SCOPING SUMMARY REPORT

NEW ENGLAND CLEAN POWER LINK TRANSMISSION LINE PROJECT ENVIRONMENTAL IMPACT STATEMENT

**U.S. Department of Energy
Office of Electricity Delivery and Energy Reliability
Washington, DC 20585**

November 2014

FIGURE 1-2 NEW ENGLAND CLEAN POWER LINK PROJECT REVISED PROPOSED ROUTE

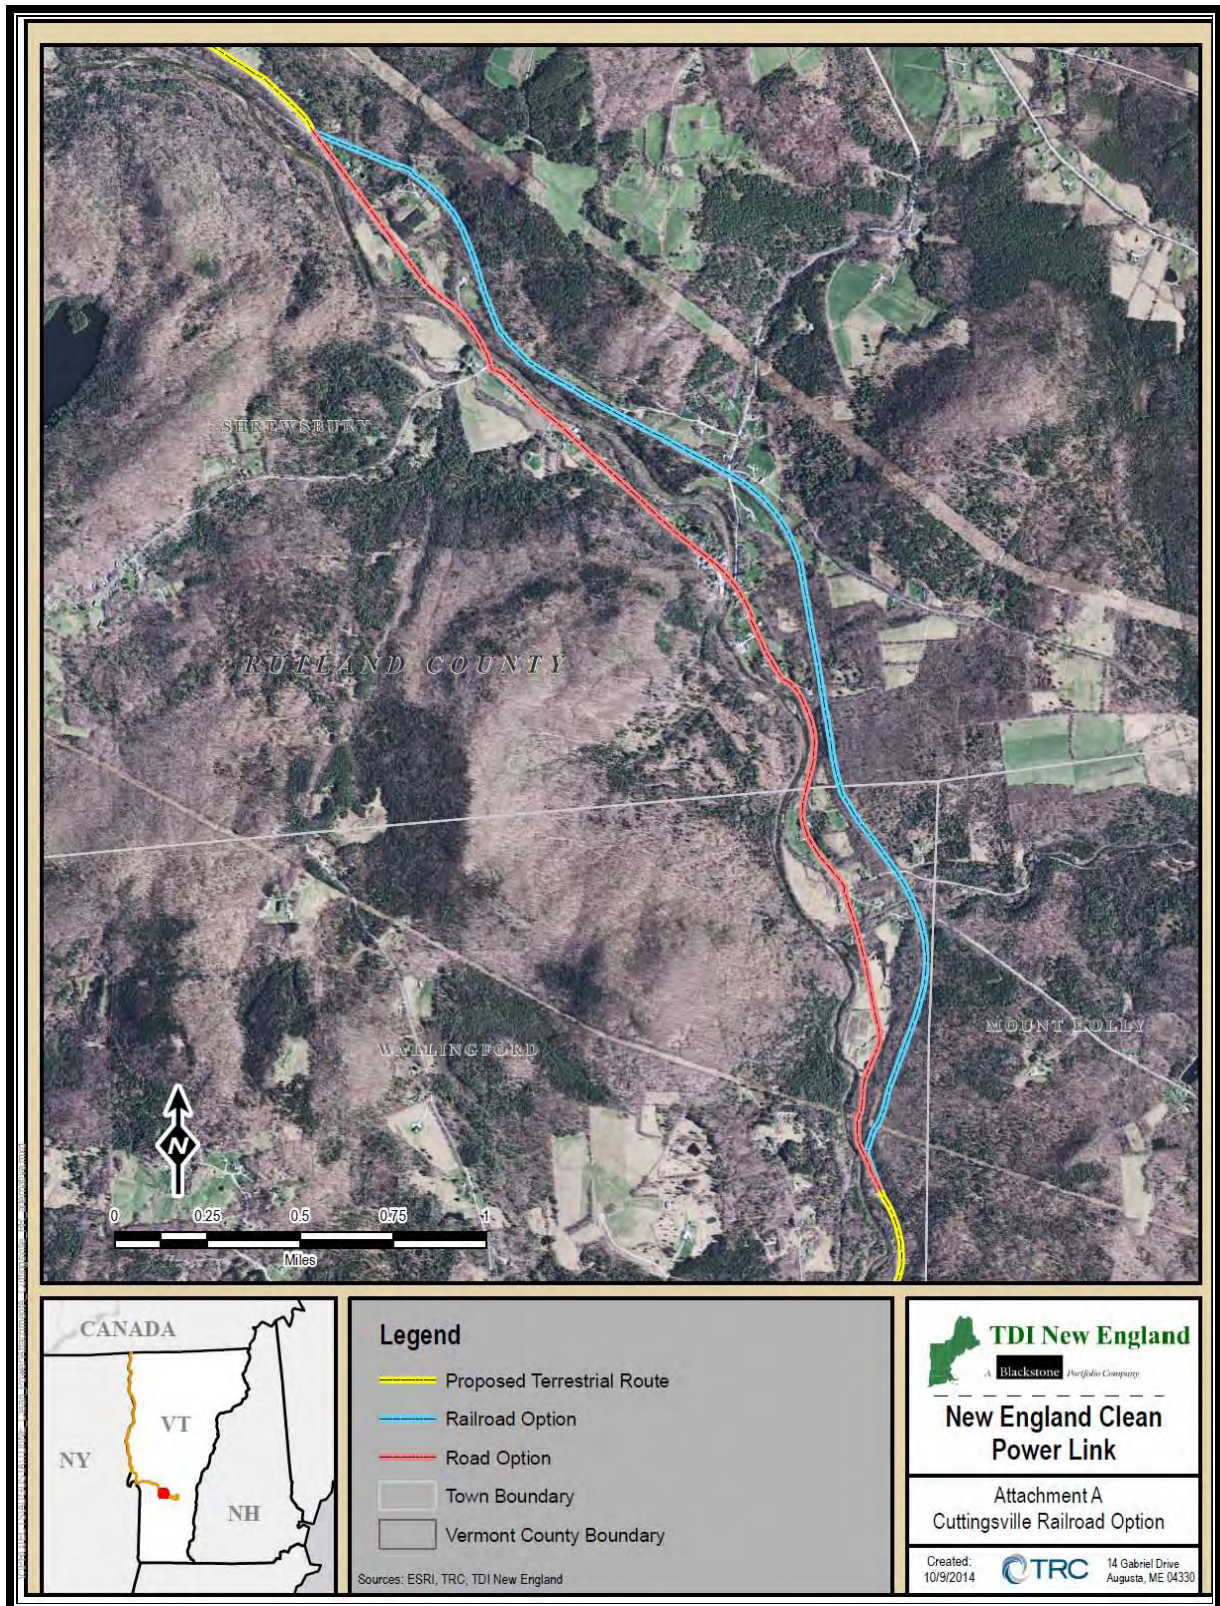
In addition to DOE's scoping activities, TDI-NE is directly engaging stakeholders along the proposed route in order to refine its proposed route for the NECPL project and avoid resources valued by the state of Vermont. In response to stakeholder input from this outreach, TDI-NE proposed to change the NECPL Project route to avoid the Village of Cuttingsville, Vermont because the village is listed as a historic district in the Vermont State Register of Historic Places and also because of discussions with stakeholders. On October 9, 2014, TDI-NE submitted a letter outlining this minor adjustment to the NECPL Project proposed route. The revised route would go through an existing railroad ROW (instead of Route 103), approximately 2 miles southeast of Clarendon/Shrewsbury border and then travel down the railroad ROW for approximately 3.6 miles and exit near the elevated railroad trestle (Figure 1-2).
